Feedback Report

Consultation on revised ATS route structure over the Irish Sea

(Isle of Man and Antrim Sectors of NATS'
Prestwick Centre)

27th January 2017

Figure 9 Liverpool STAR revisions

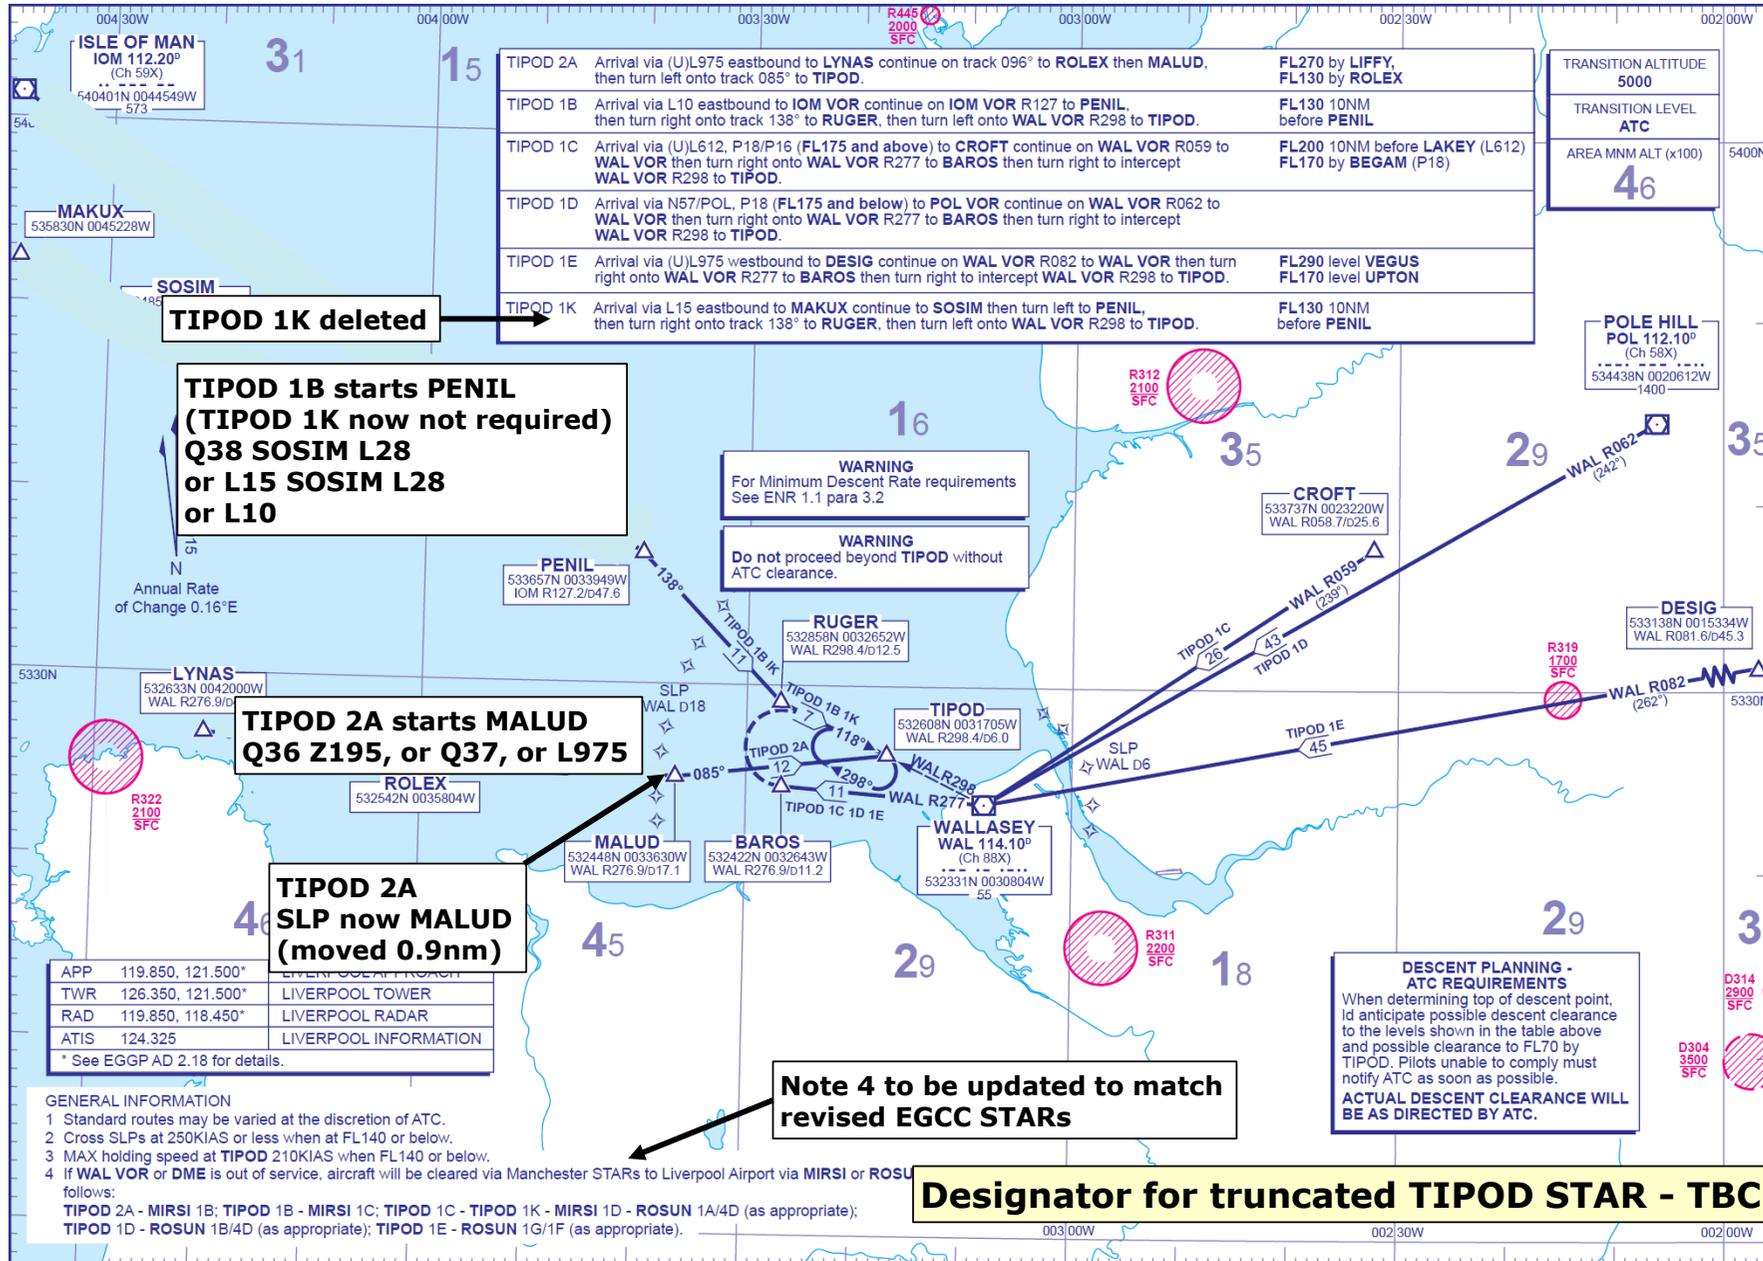
Appendix B of the consultation document illustrated how STARs into Manchester and Liverpool Airports would be truncated under this proposal. These will be progressed.

As previously discussed, some routes and network links will be updated following feedback received. The consulted-upon truncations will be suitably modified to ensure appropriate connectivity is retained. The arrival route options available under this proposal mean that several other STAR charts will also be amended, some in an editorial manner.

Figure 10 Stansted and Luton STAR revision (ASKEY equivalents required, not shown)

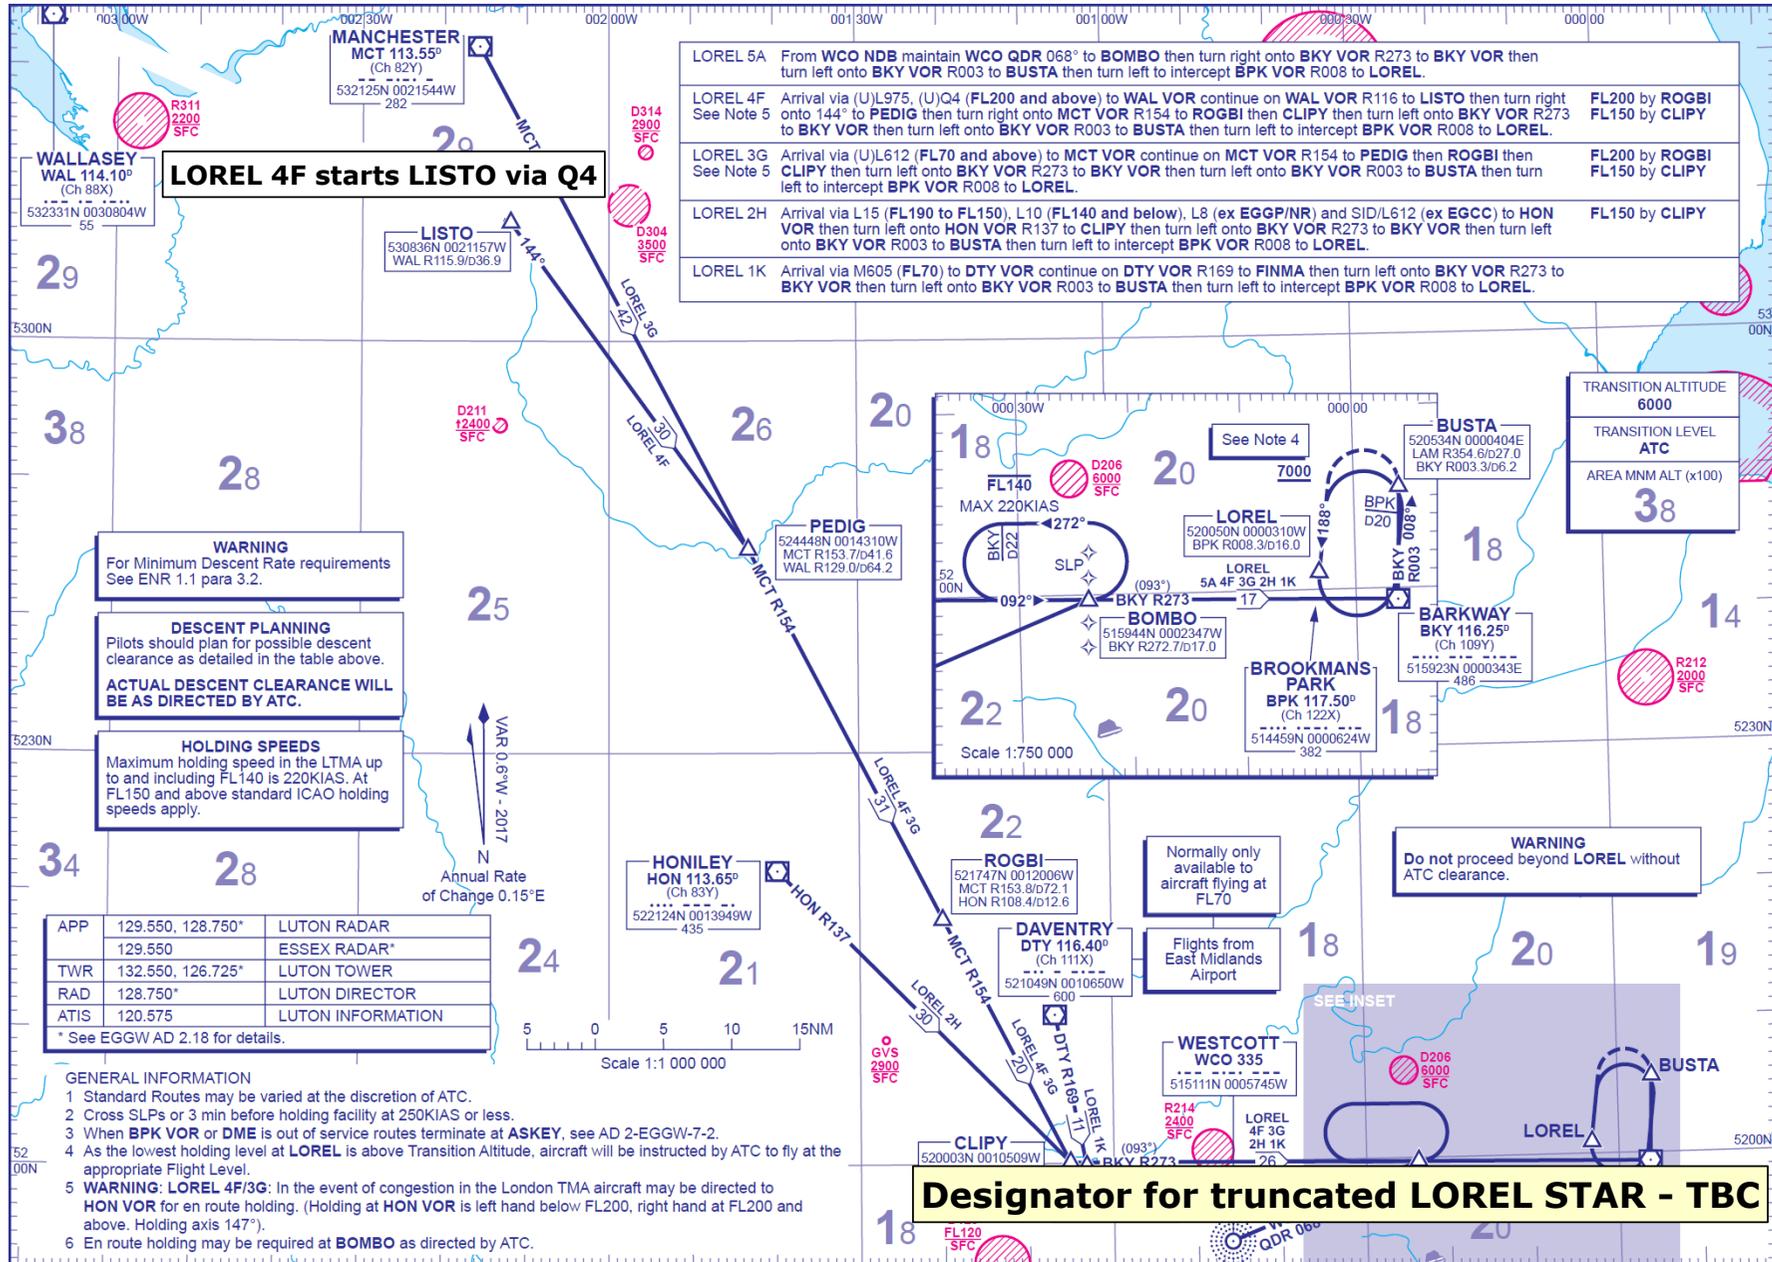
Existing STARs into London City, Luton, Stansted and Southend will be amended at high levels without changing flight-paths at low altitudes. In order to facilitate this connectivity we propose to modify ATS route Q4 by adding a slight kink via waypoint LISTO. This kink would add less than 70 metres to flightplan track lengths for arrivals at these three airports and would benefit the wider network overall.
